William Kennedy, P.E., *Comments Regarding the Proposed NPDES
Permit for Public Service of New Hampshire's Merrimack Station
(August 2014)*

Comments Regarding the Proposed NPDES Permit
for
Public Service of New Hampshire's
Merrimack Station

William Kennedy, P.E.

August 2014

Schema Impianto Evaporazione-Cristallizzazione di La Spezia

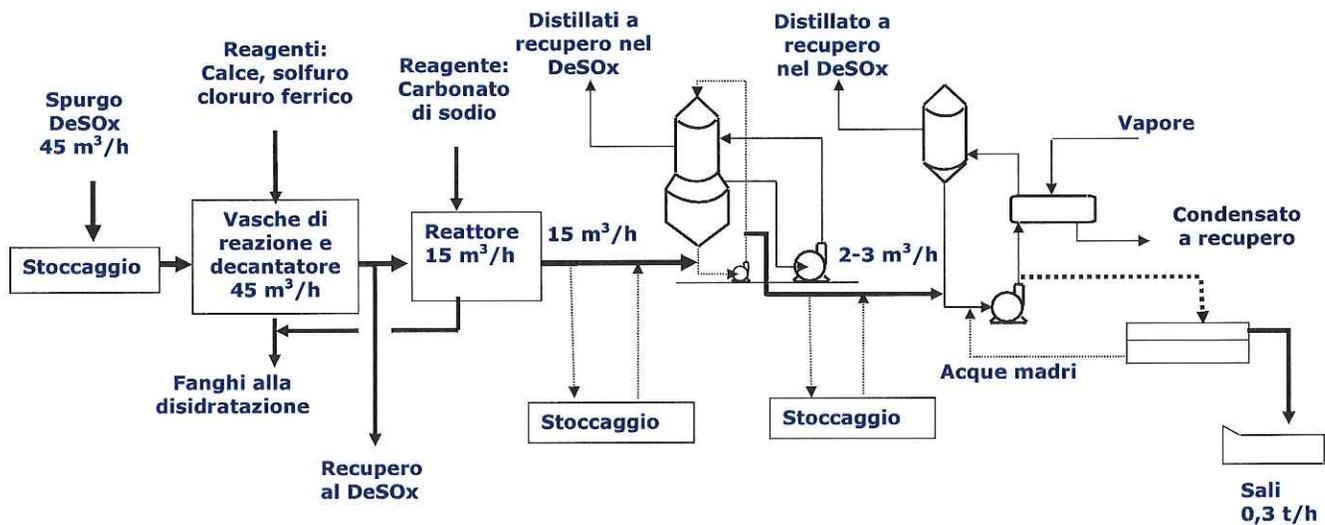
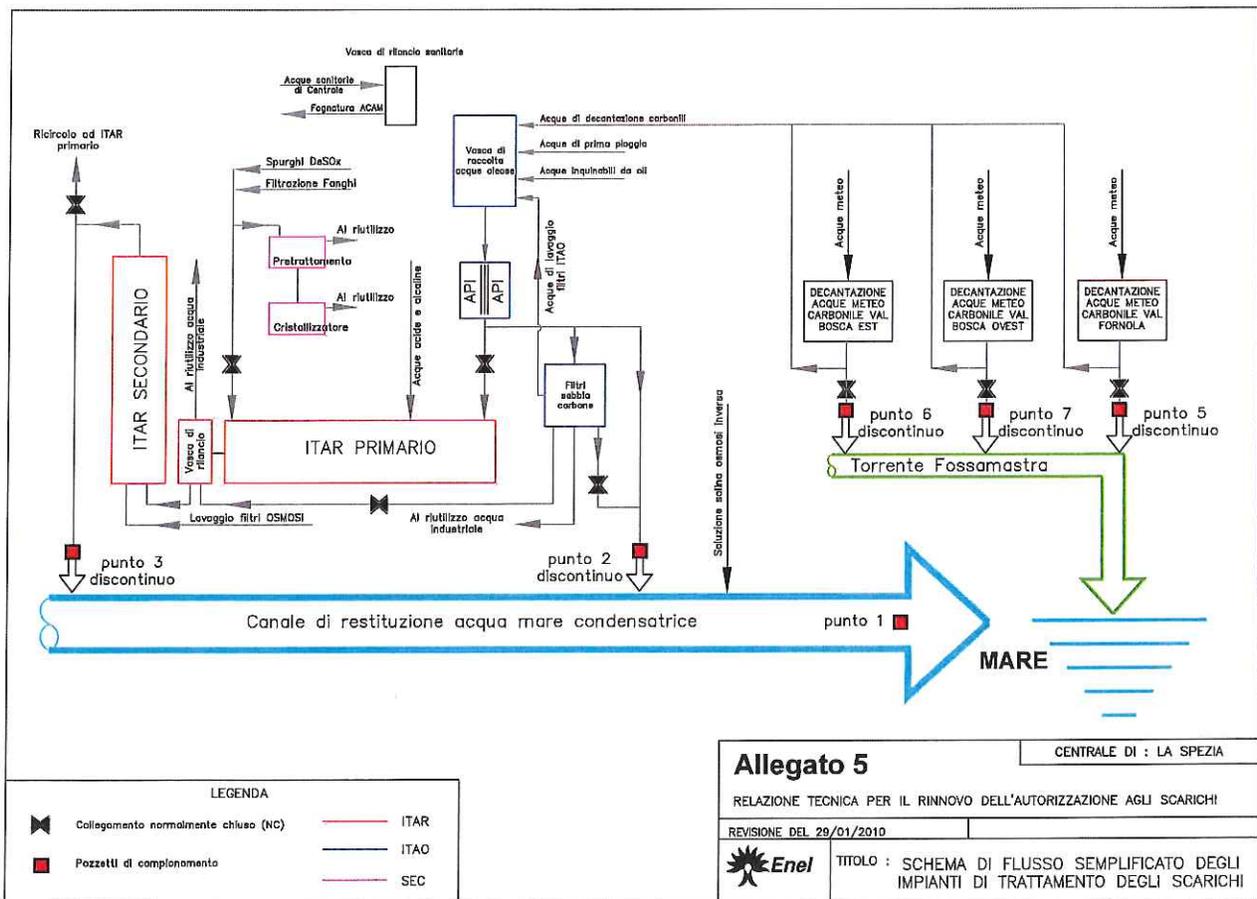
- Considering wastewater flow diagram provided by the site for the permit application and included in the EMAS statement 2012, it is clear that the FGD discharge can go either to the ITSD/SEC plant (chemically treated, evaporated, condensed and then reused) or to ITAR (chemically treated and then reused or discharged to sea). A "normally closed" valve is indicated in the flow diagram on the connection between FGD and ITAR (see Appendix B).

CENTRALE TERMOELETTRICA DI BRINDISI SUD SCHEMA DI TRATTAMENTO ACQUE REFLUE

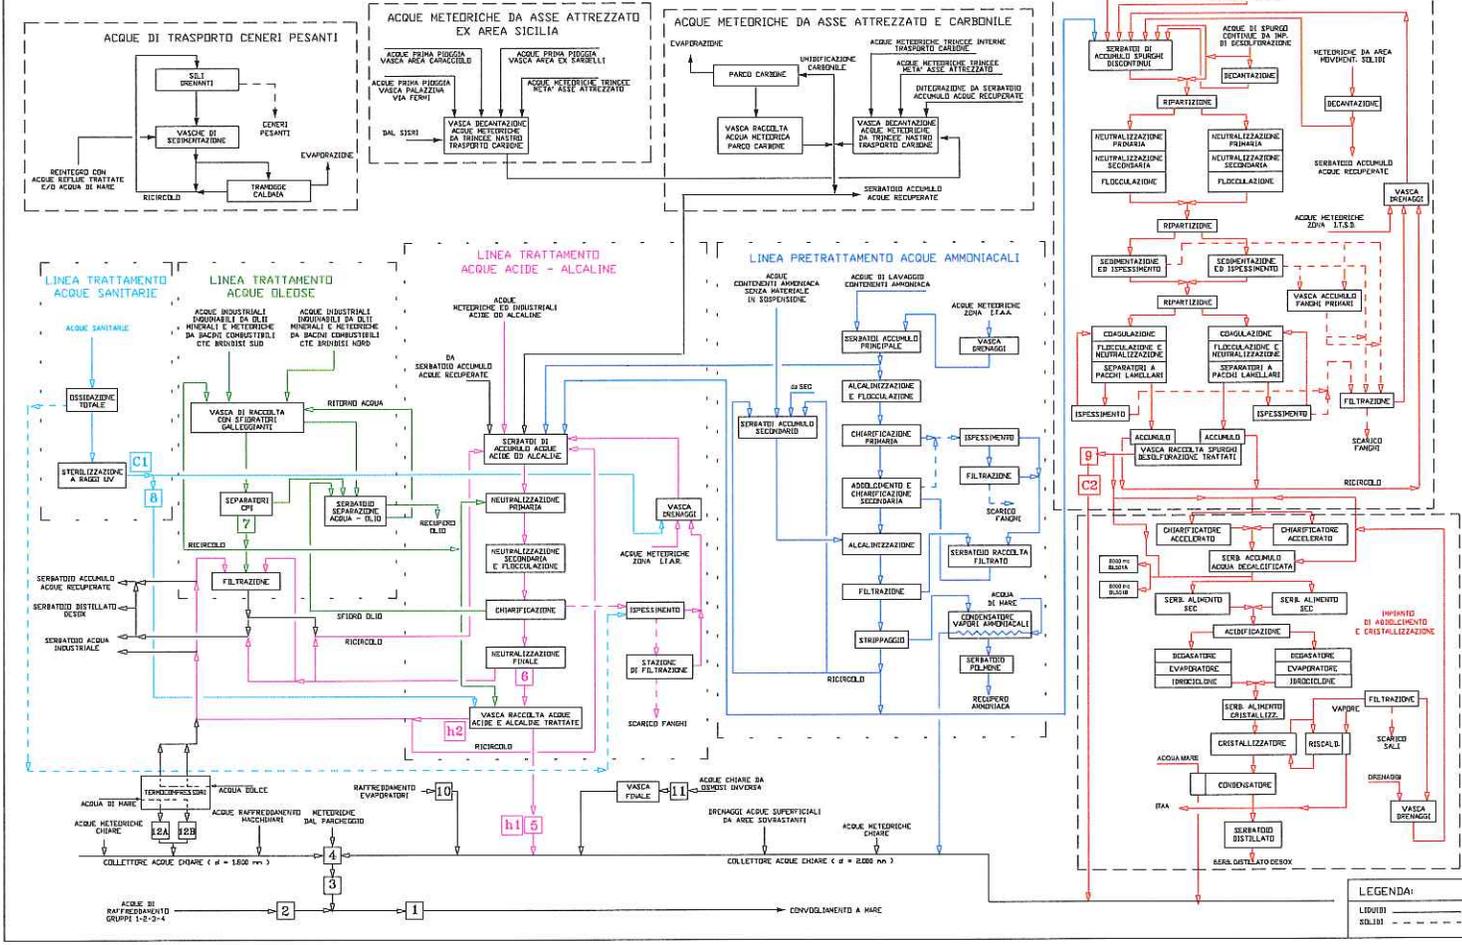
- In a process flow diagram of the site wastewater treatment system (attached to the permit application), a stream named "C2" goes directly from ITDS plant to the sea, likely the S9S discharge point (see Appendix C).
